SUBJECT

Recall Campaign 11V-521: Replace the Auxiliary Coolant Pump for Turbocharger

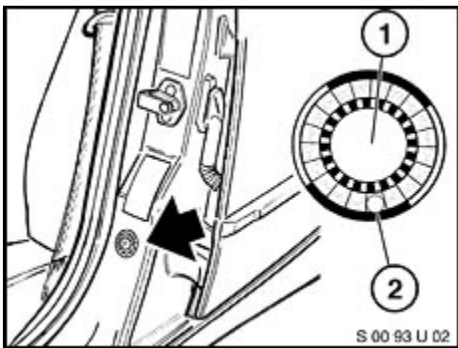
Moisture ingress into the electronics of the turbocharger auxiliary coolant pump could cause a short circuit. This short circuit may cause the auxiliary water pump to overheat. In rare cases where overheating occurs, a fire in the engine compartment or in the entire vehicle is possible.

Replace the auxiliary water pump for the turbochargers with an improved pump (refer to parts information). Refer to Repair Instruction RA 11 53 000 (5, 6 and 7 Series) or RA 11 53 090 (X5 and X6) for replacement of the pump and proper coolant bleeding procedures.

This repair procedure involves draining a small quantity of coolant; replenish the drained quantity with new BMW long-term Antifreeze/Coolant (50/50 mixture). Do not reuse the drained coolant.
